ARIZONA DEPARTMENT OF ENVIRONMENTAL QUALITY

Re: Mitigation Order, Docket No: P-50-06 – Review of Aquifer Characterization Report

The Arizona Department of Environmental Quality (ADEQ) has completed its review of the December 28, 2007 Aquifer Characterization report (ACR) submitted by Freeport MacMoRan Sierrita Inc. (Freeport). ADEQ has concerns about the ACR that are described in more detail in the attached comments, but the main concerns are as follows:

GENERAL COMMENTS

Approved KW	Date 11/28/07	Revised	Date	Reference: 7830164A	FIG. H.2b
----------------	------------------	---------	------	------------------------	--------------

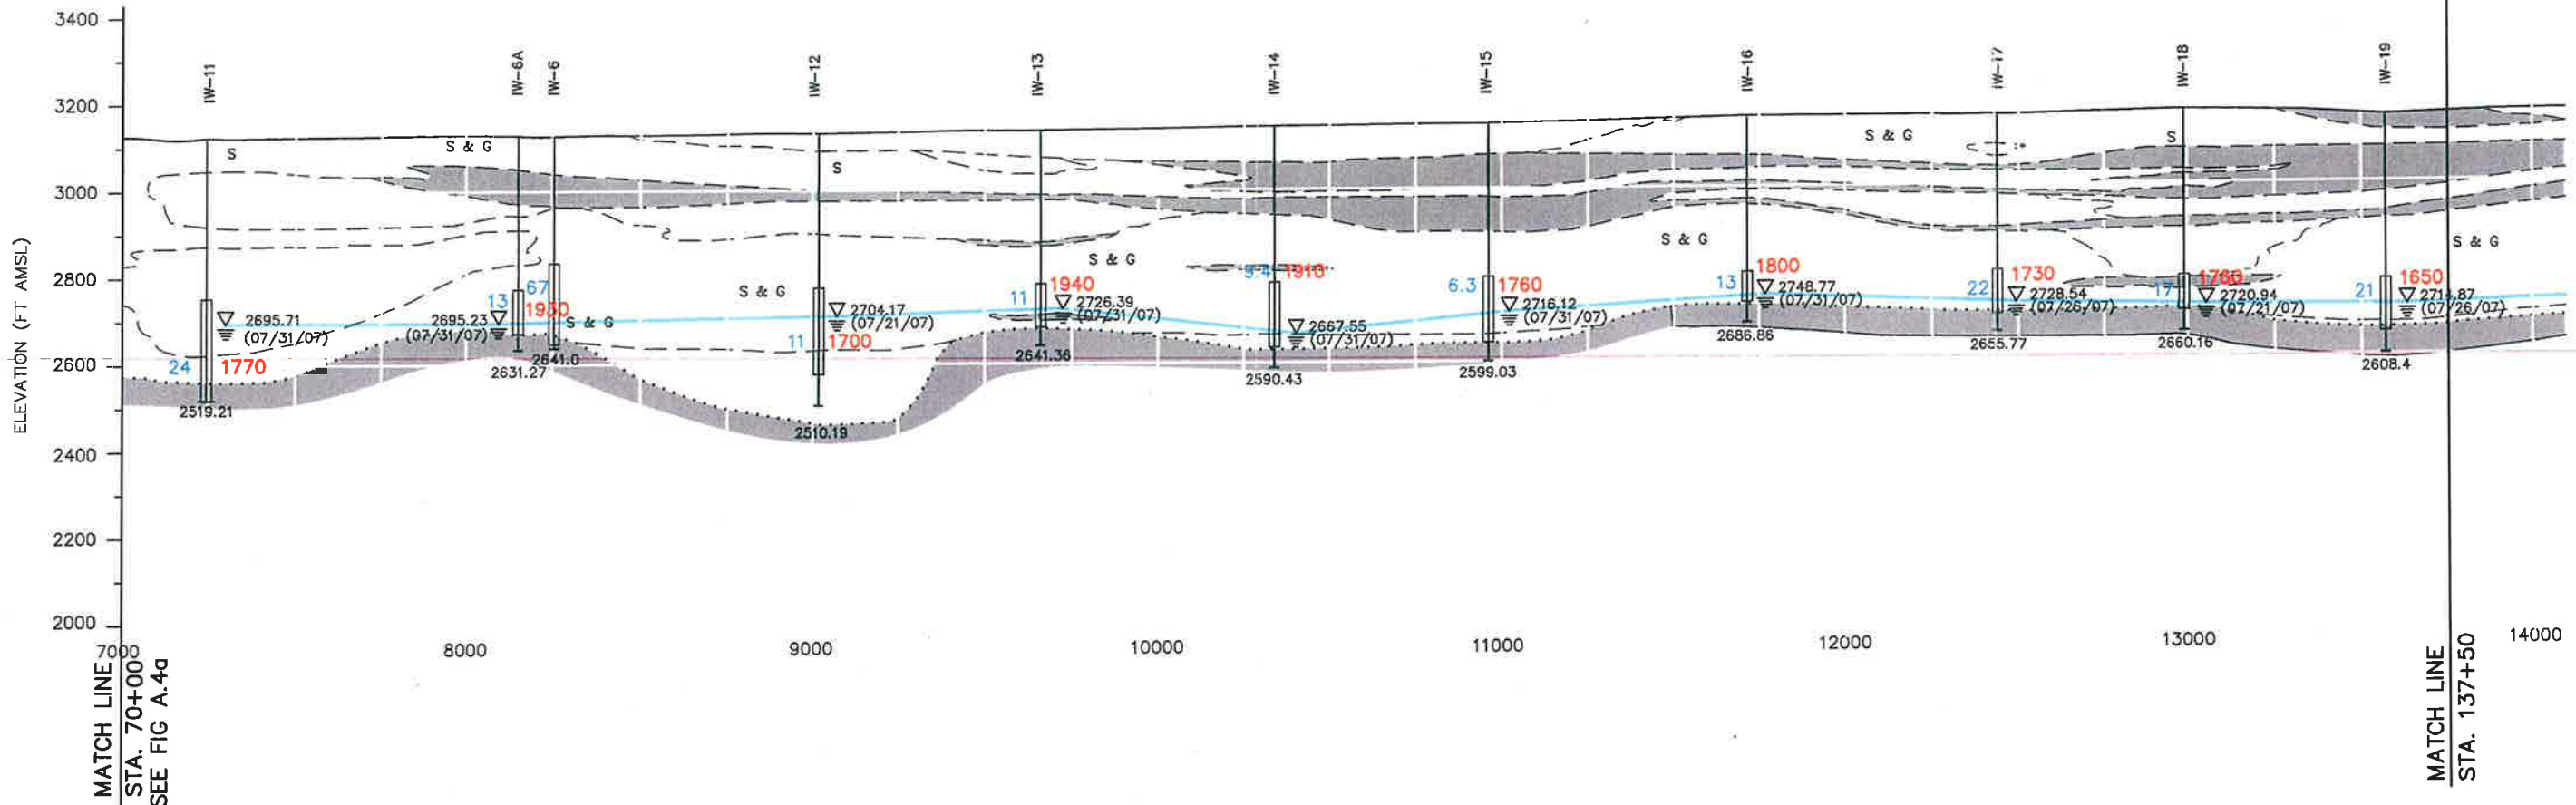
Freeport states in the last sentence of the first paragraph "*The contours on Figures 1 and 4 were developed using the highest measured sulfate concentrations at co-located wells,*" but the report does not provide a rationale as to why the highest concentration of sulfate was used. ADEQ believes it would be more informative to contour the sulfate data per potential hydrostratigraphic units. Freeport also should discuss the vertical distribution of sulfate within the basin fill aquifer, and include cross-sections that post and contour the sulfate data (See Attachments).

Handwritten note: ?-1000 sulfate concentration contour, queried where uncertain.

Approved KW	Date 11/29/07	Revised	Date	Reference: 7830163A	FIG. H.2a
----------------	------------------	---------	------	------------------------	--------------

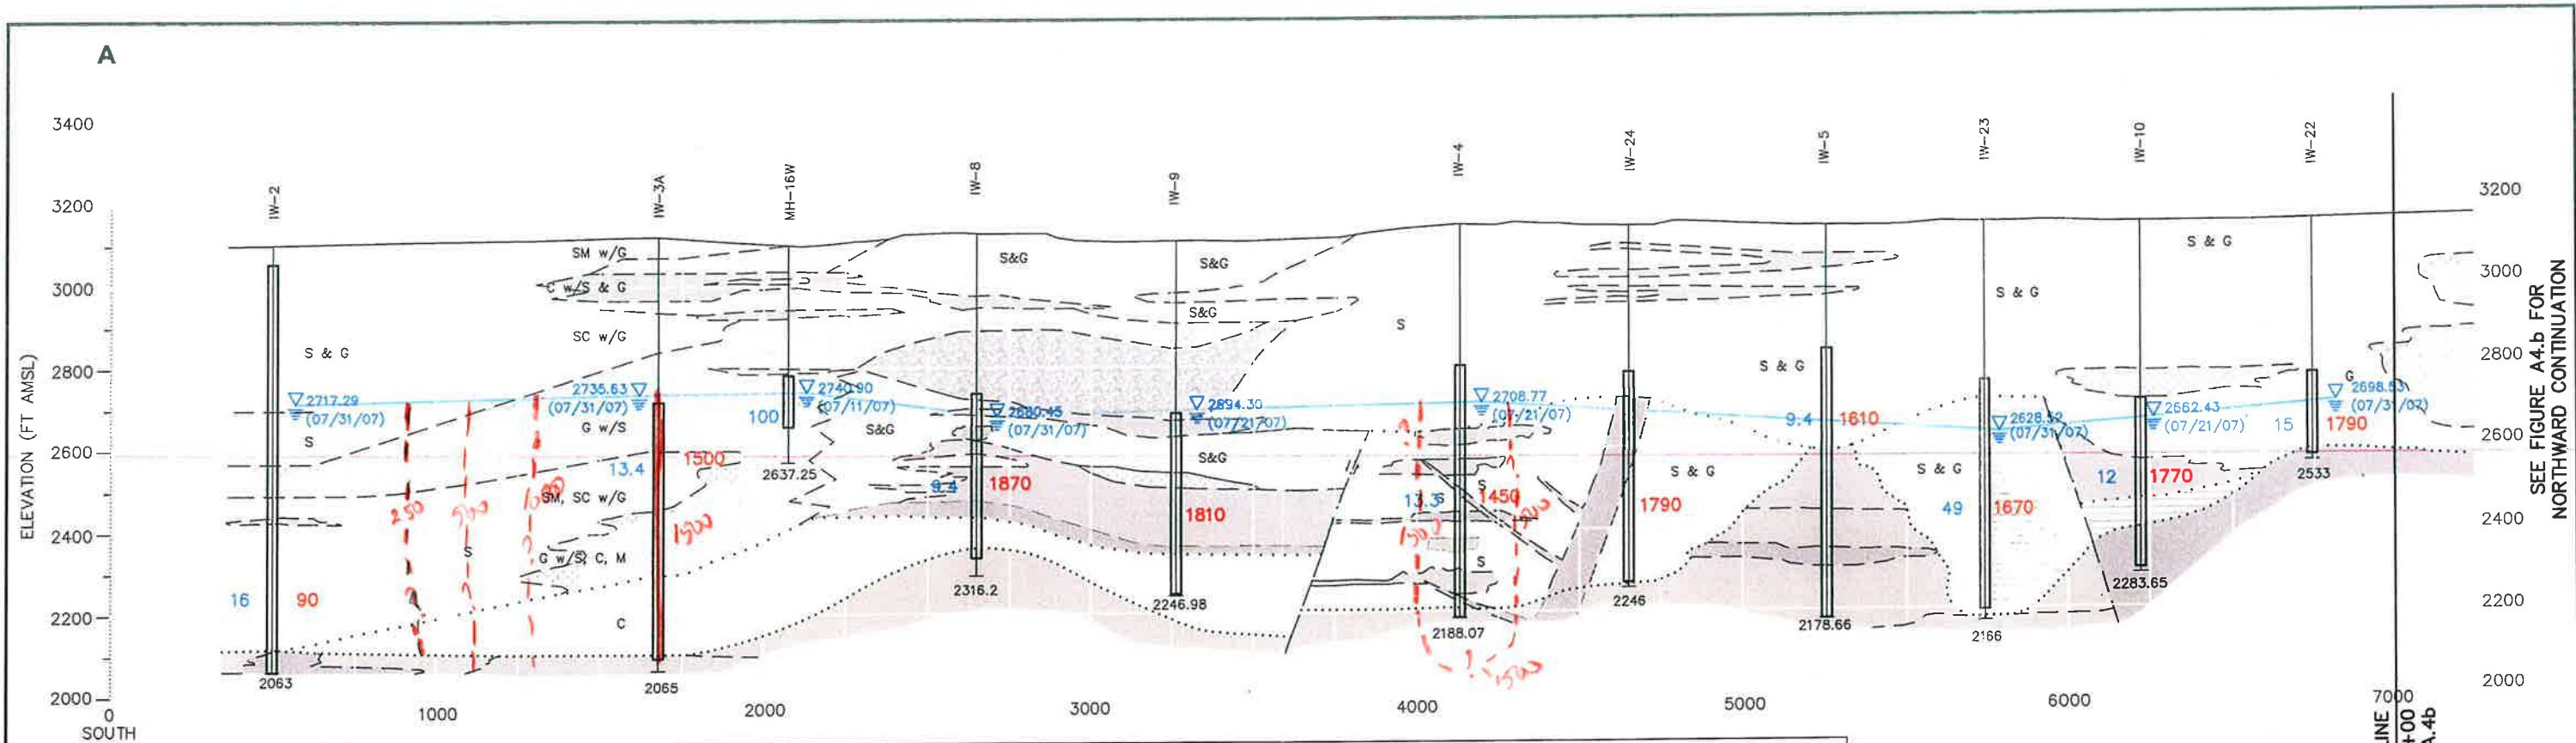
Sulfate concentration contours, queried where uncertain

Approved	Date	Revised by	Date	File Name	Figure
KW	11/29/07	KW	11/29/07	7830165A	H.3a

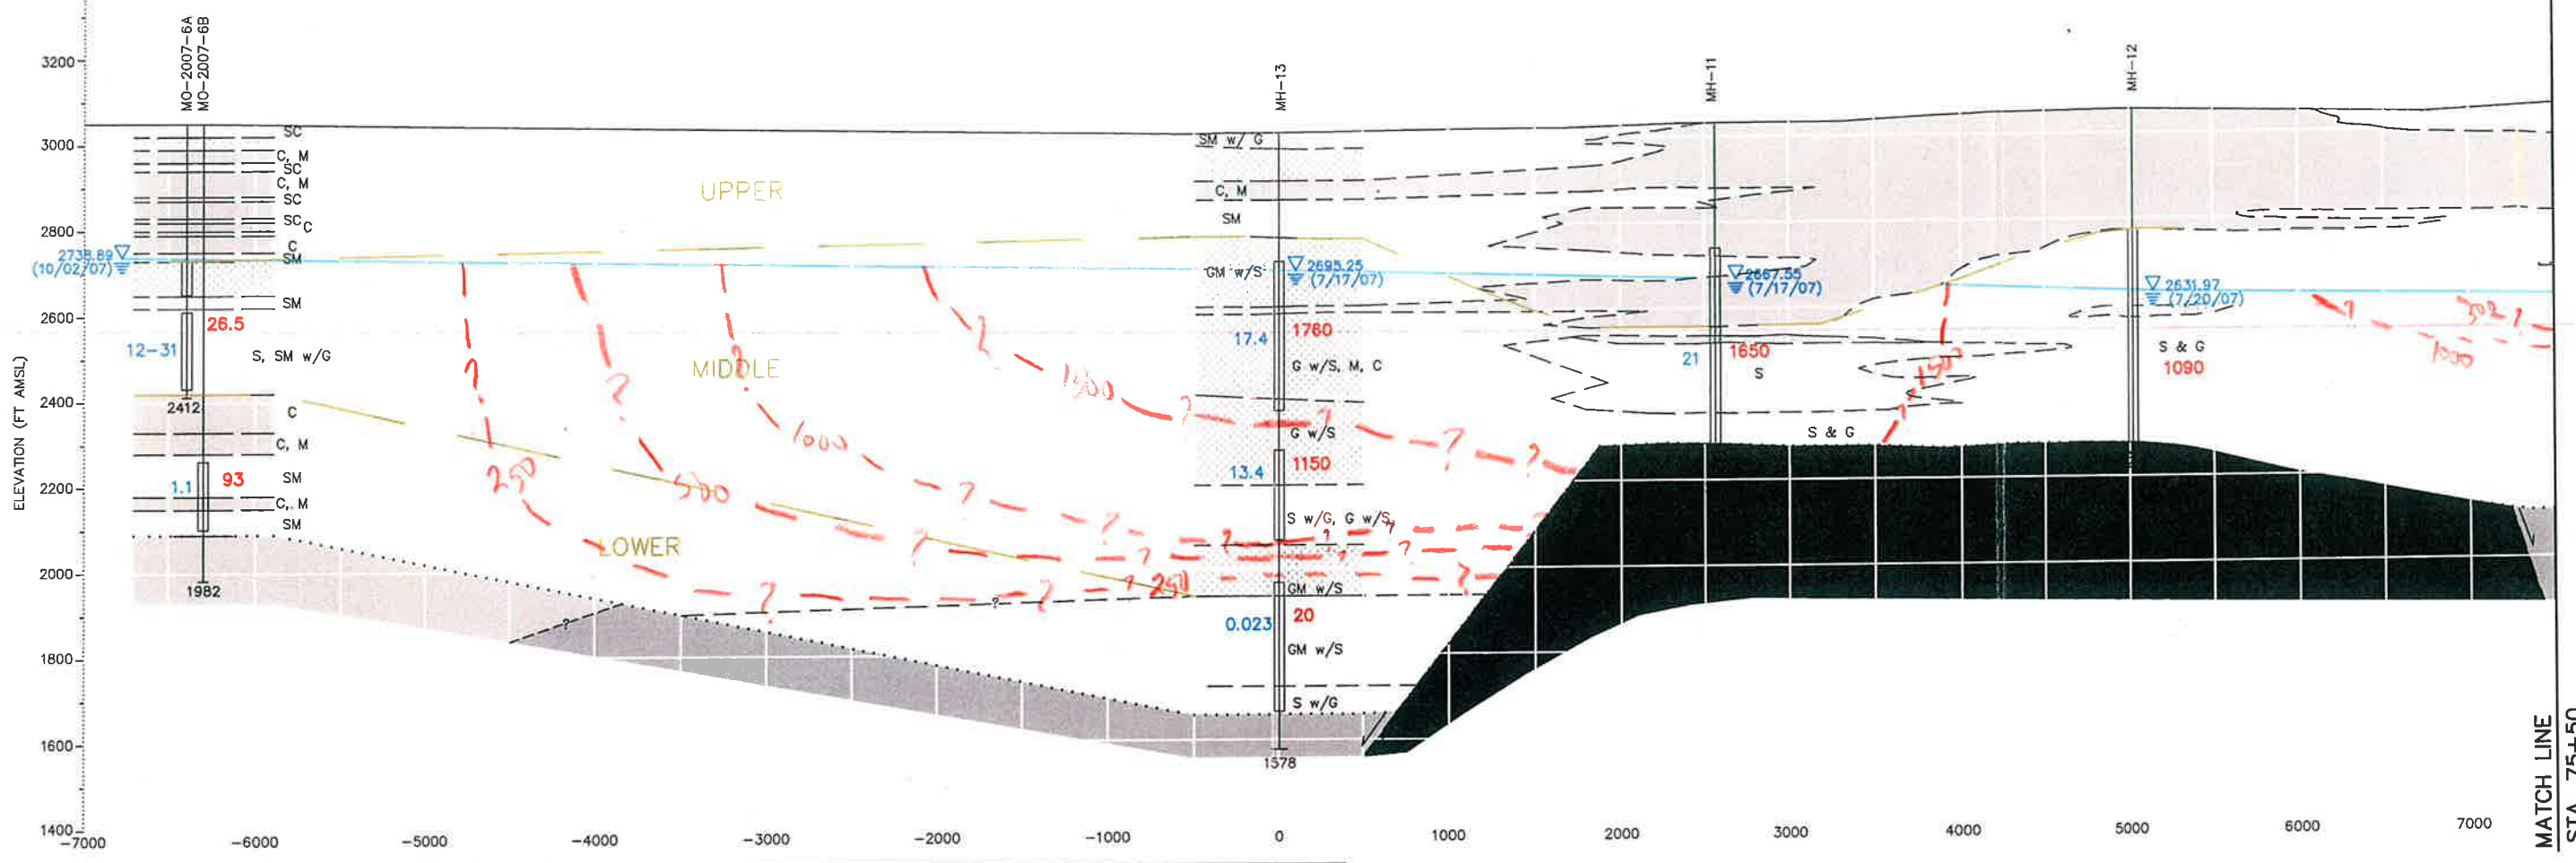
Handwritten: Sulfate concentration contour, queried where uncertain

Approved KW	Date 11/29/07	Revised by KW	Date 11/29/07	File Name 7830165A	Figure H.3b
-----------------------	-------------------------	-------------------------	-------------------------	------------------------------	-----------------------

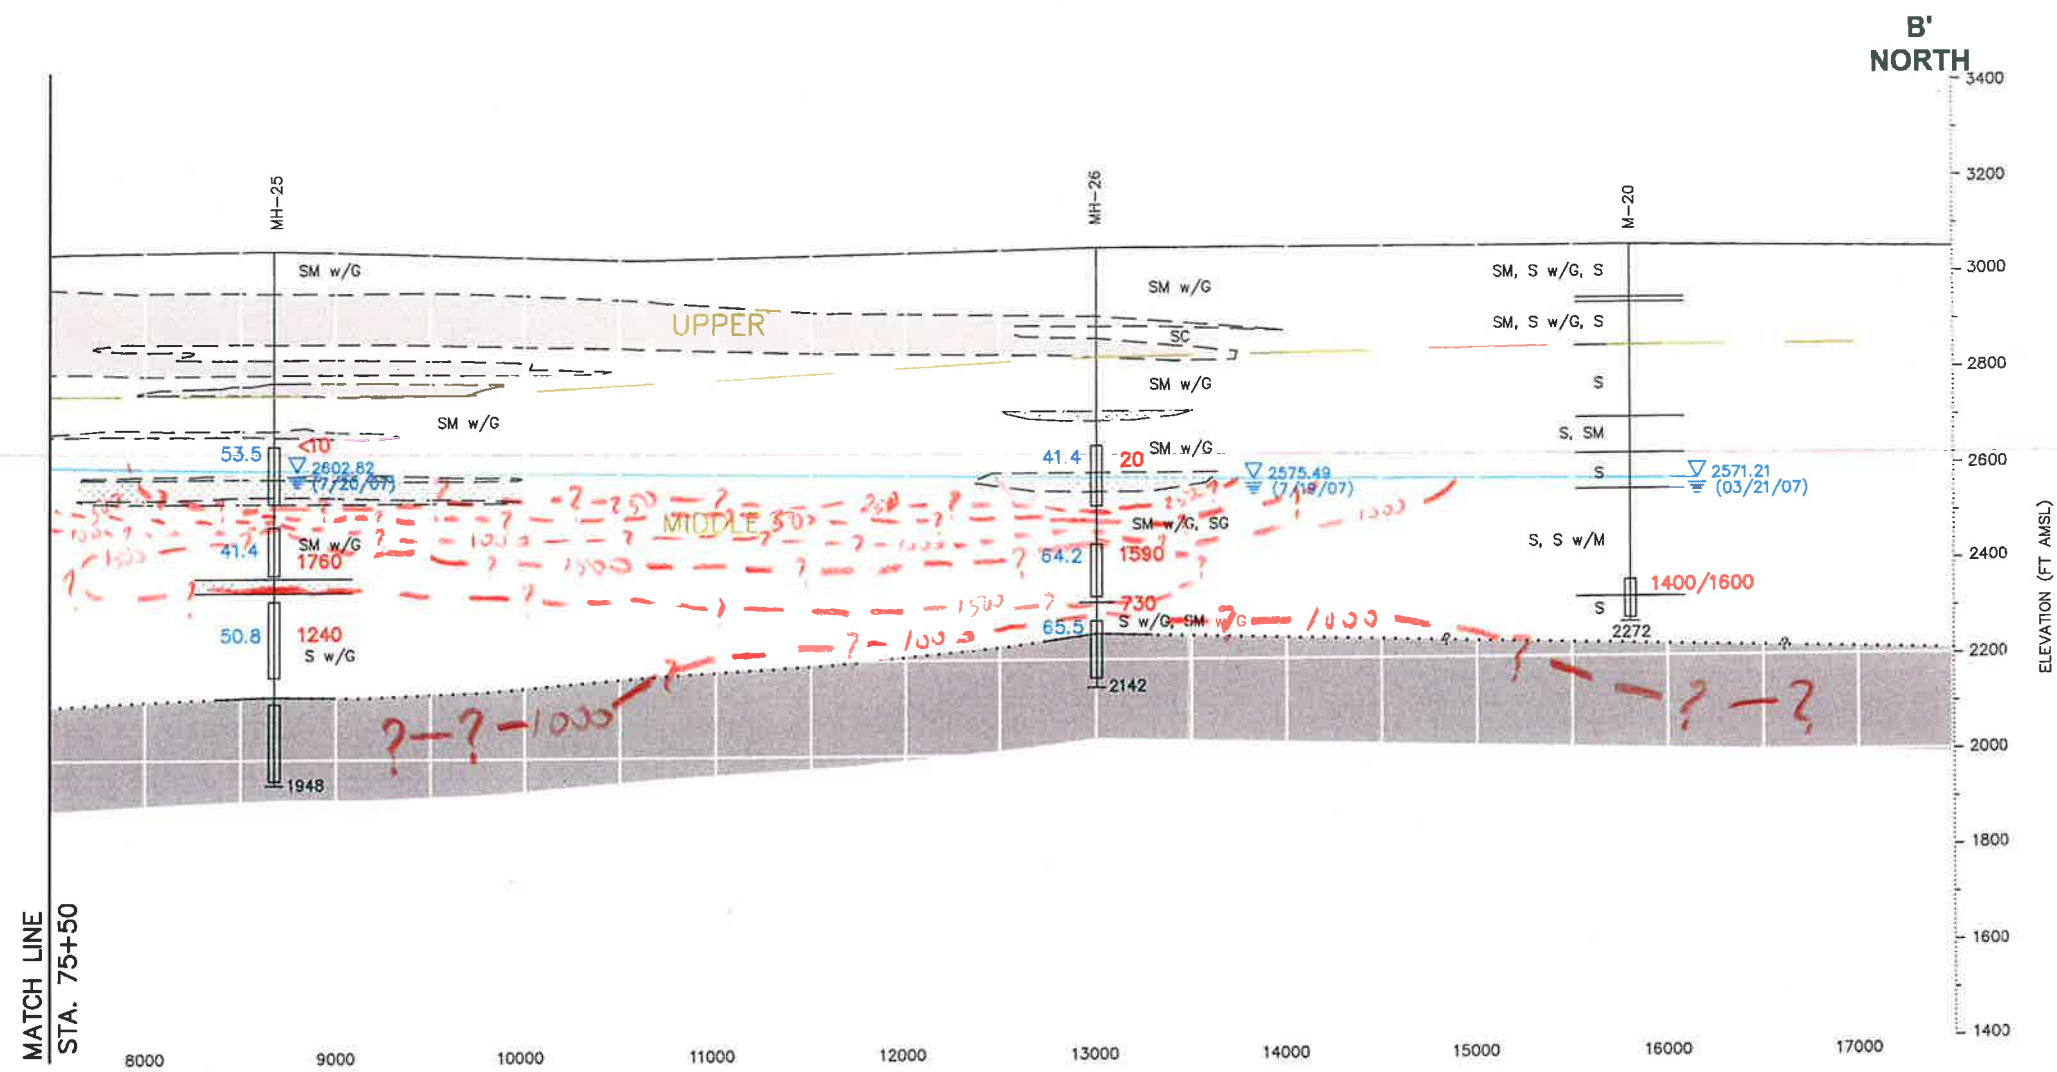
Handwritten note: - sulfate concentration contours, guessed where unknown.

Approved KW	Date 11/29/07	Revised	Date	Reference: 7830166A	FIG. H.4a
-----------------------	------------------	---------	------	------------------------	--------------

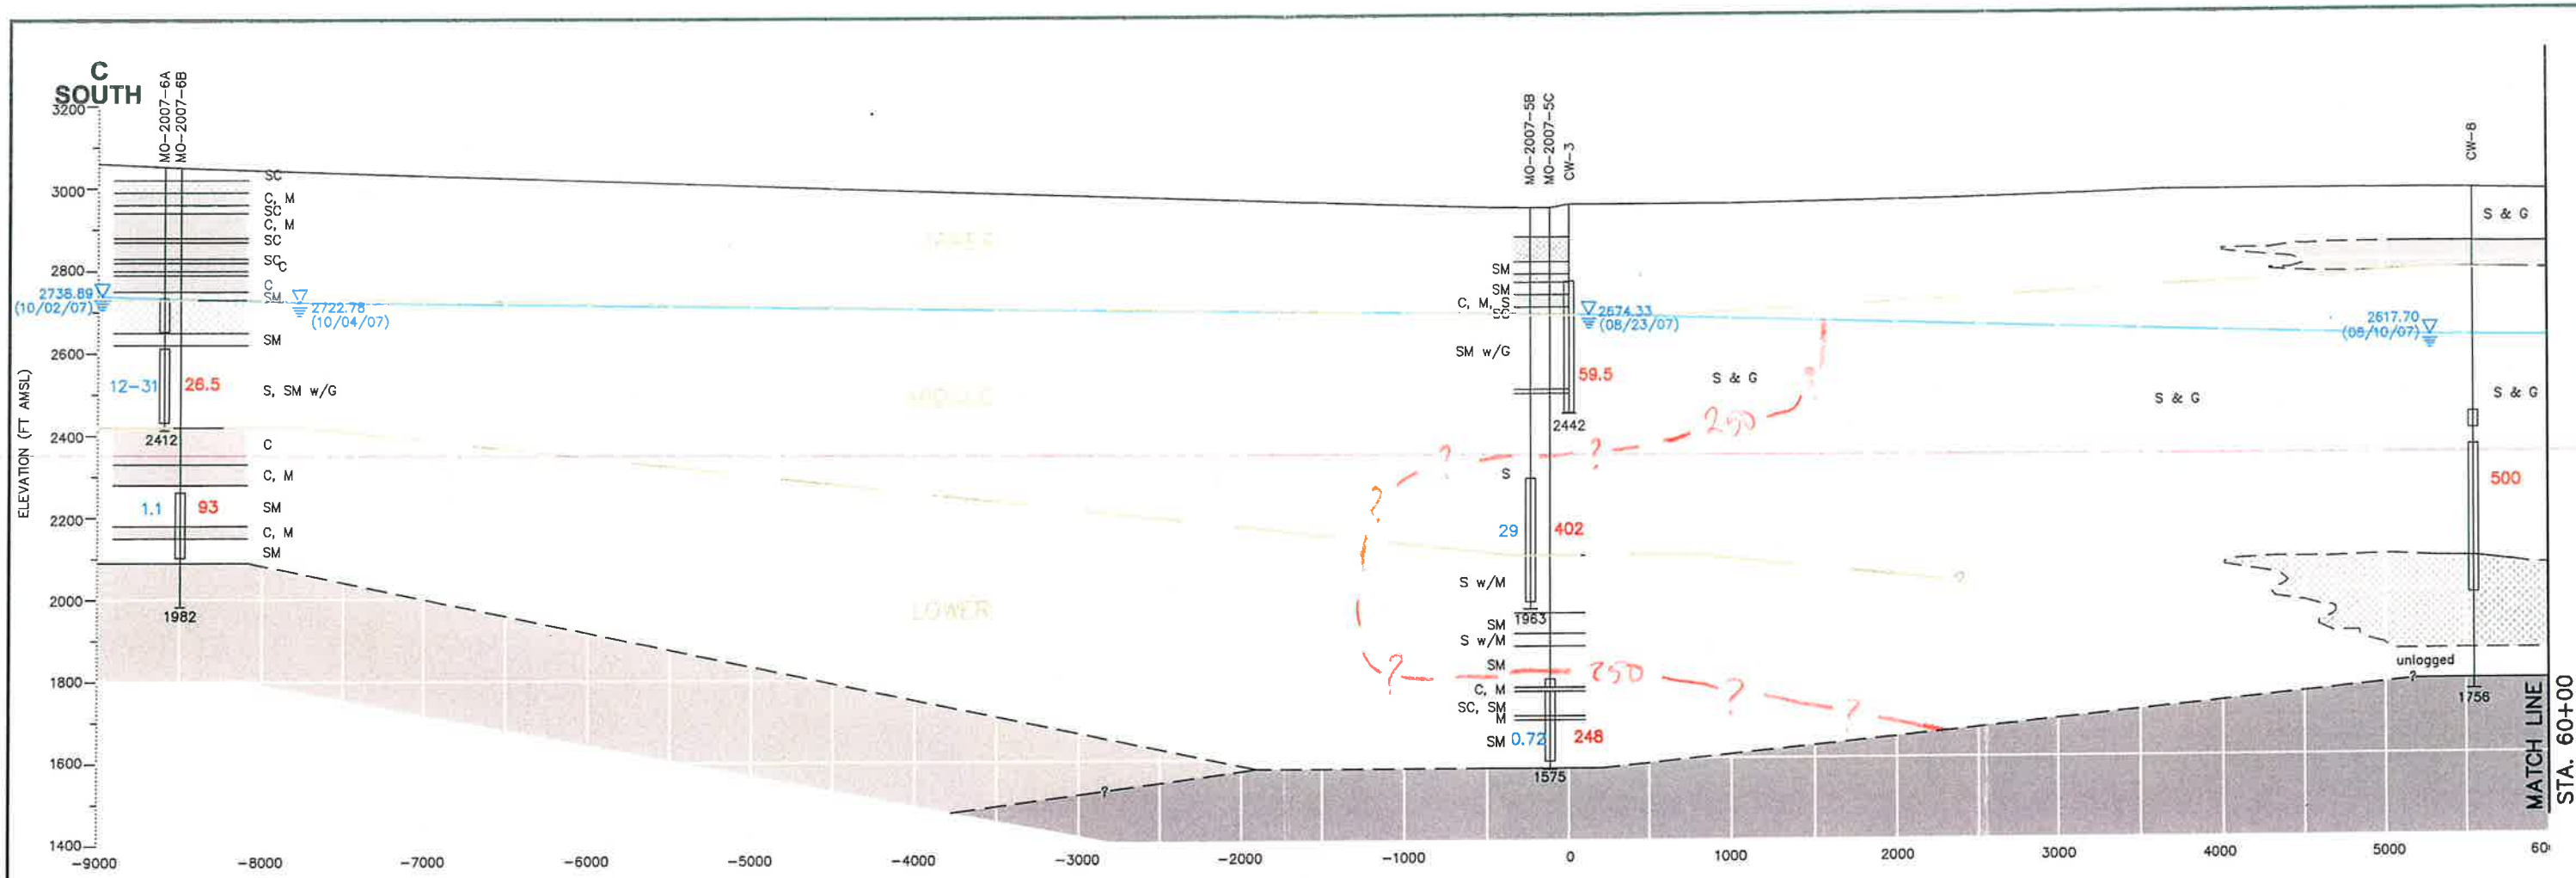
? - 1000 - Sulfate concentration contours, queried where uncertain
